Project	<b>IEEE 802.16 Broadband Wireless Access Working Group</b> < <a href="http://ieee802.org/16">http://ieee802.org/16</a> >	
Title	<b>Comments and Proposed SDD Text for Multi-Carrier Frame Structure</b>	
Date Submitted	<b>2008-03-17</b>	
Source(s)	Mo-Han Fong, Jianglei Ma, Sophie Vrzić, Robert Novak, Jun Yuan, Dongsheng Yu, Anna Tee, Sang-Youb Kim, Kathiravetpillai Sivanesan  Nortel Networks 3500 Carling Avenue Ottawa, Ontario Canada K2H 8E9	Voice: +1-613-765-8983 E-mail: <a href="mailto:mhfong@nortel.com">mhfong@nortel.com</a>  * <a href="http://standards.ieee.org/faqs/affiliationFAQ.html">http://standards.ieee.org/faqs/affiliationFAQ.html</a> >
Re:	Call for comments on C802.16m-08/118r1	
Abstract	This contribution proposes the SDD text for multi-carrier frame structure	
Purpose	To incorporate the proposed text into the Project 802.16m System Description Document	
Notice	<i>This document does not represent the agreed views of the IEEE 802.16 Working Group or any of its subgroups. It represents only the views of the participants listed in the "Source(s)" field above. It is offered as a basis for discussion. It is not binding on the contributor(s), who reserve(s) the right to a

Figure 11.4.3-1 Multiplexing of legacy and 16m channels

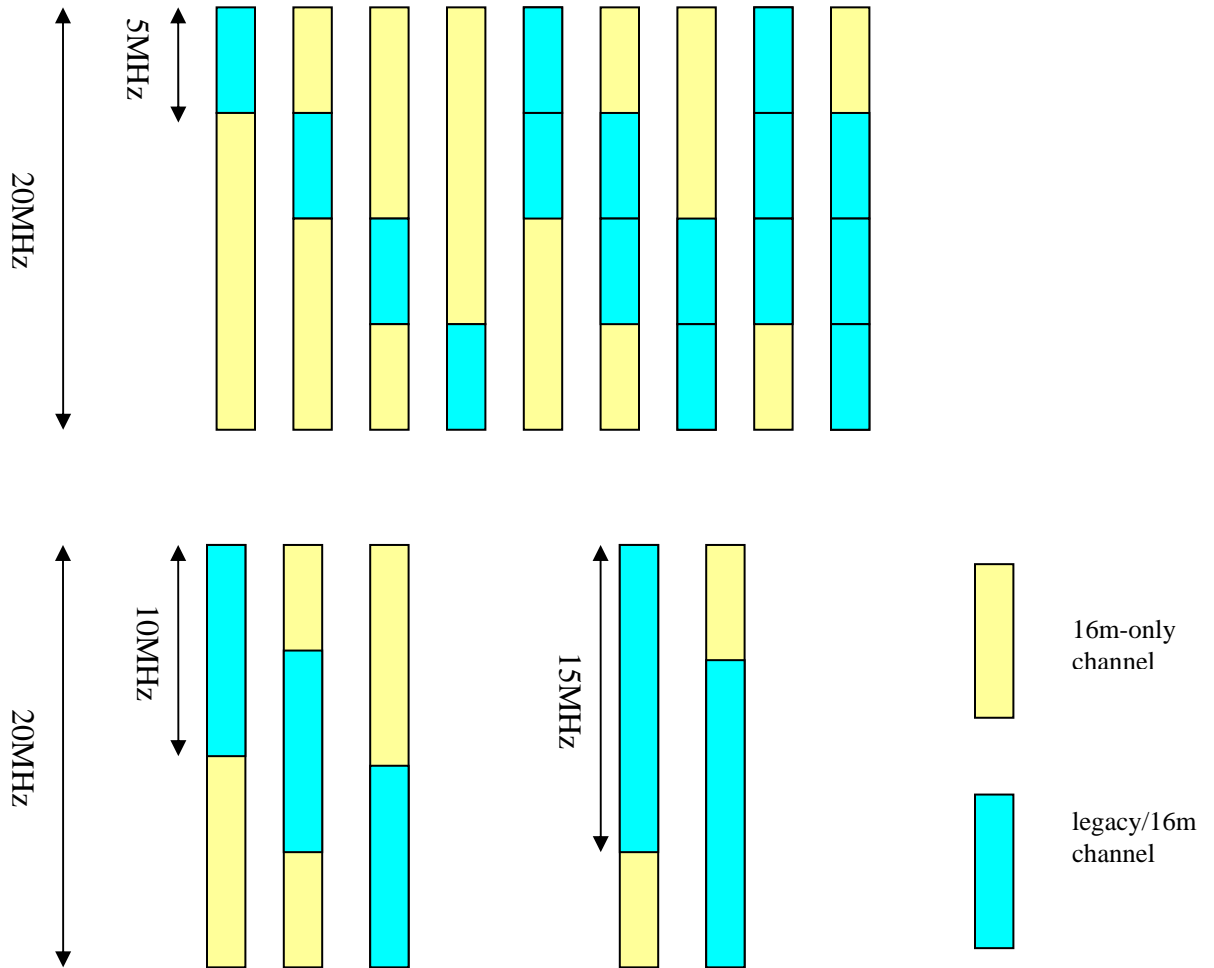
In the case where the 802.16m has a wider bandwidth than the legacy system, there can be one or more legacy enabled channels assigned within the band. The legacy enabled channel(s) can be assigned at different locations within the band per deployment needs. If the 802.16m MS bandwidth capability is at least 5MHz, the legacy enabled channel(s) can be located in increments of 5MHz as shown in Figure 11.4.3-1. Some of the legacy enabled channel(s) can be designated as legacy-only channel.

Figure 11.4.3-2 Frame Structure for the case where one legacy channel is assigned in the middle of the 802.16m band

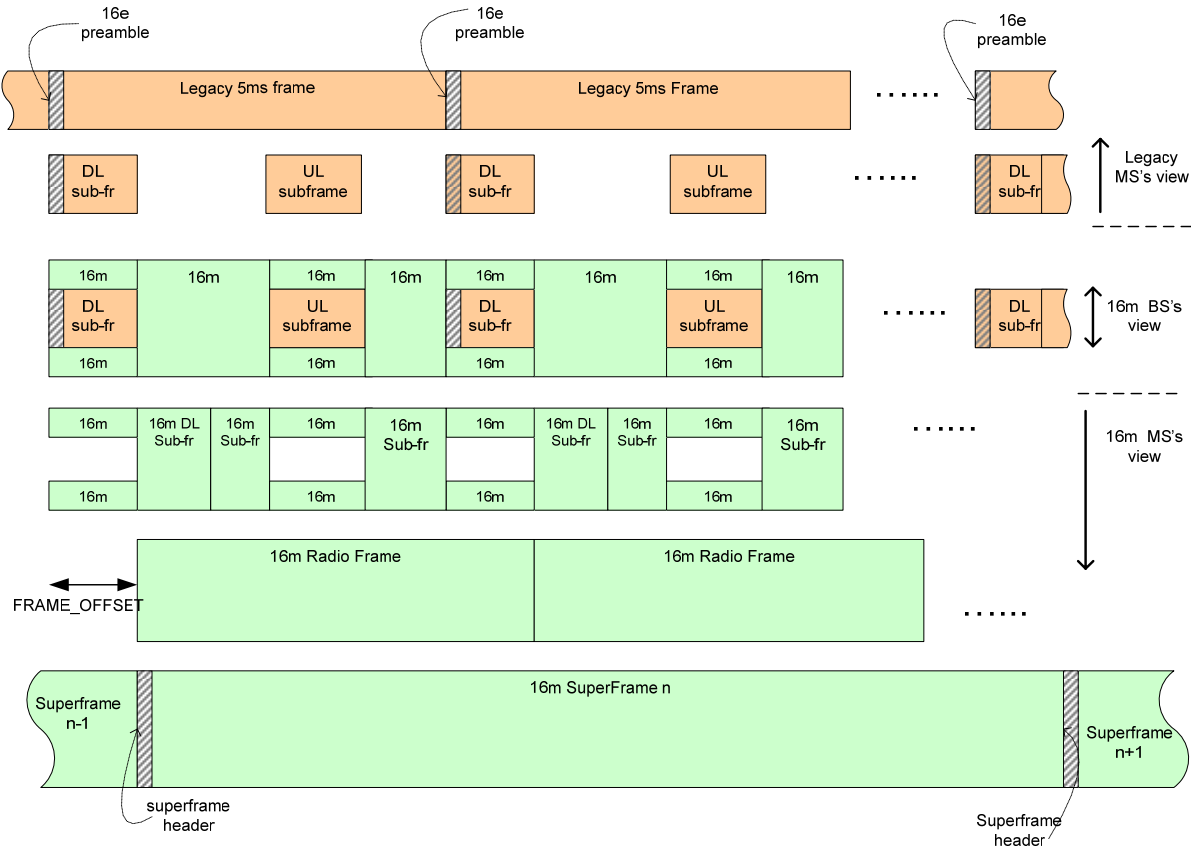
Figure 11.4.3-2 shows the frame structure for the case where one legacy enabled channel is allocated in the middle of the 802.16m band. Figure 11.4.3-3 shows the frame structure for the case where more than one legacy enabled channels is allocated within the 802.16m band. The FRAME\_OFFSET shown in Figure 11.4.3-2 and Figure 11.4.3-3 is for illustration. It is an offset between the start of the legacy frame and the start of the new frame. The value and the relative shifting direction of the FRAME\_OFFSET is for FFS. TDM and/or FDM multiplexing of legacy and 16m resource is for FFS. The UL sub-frame shown in the figure does not preclude TDM or FDM multiplexing. In a sub-frame that contains both legacy enabled channel and 802.16m channel, guard bands shall be assigned between adjacent legacy enabled channel and an 802.16m channel. In a sub-frame that contains only 802.16m channel, guard bands may be omitted.
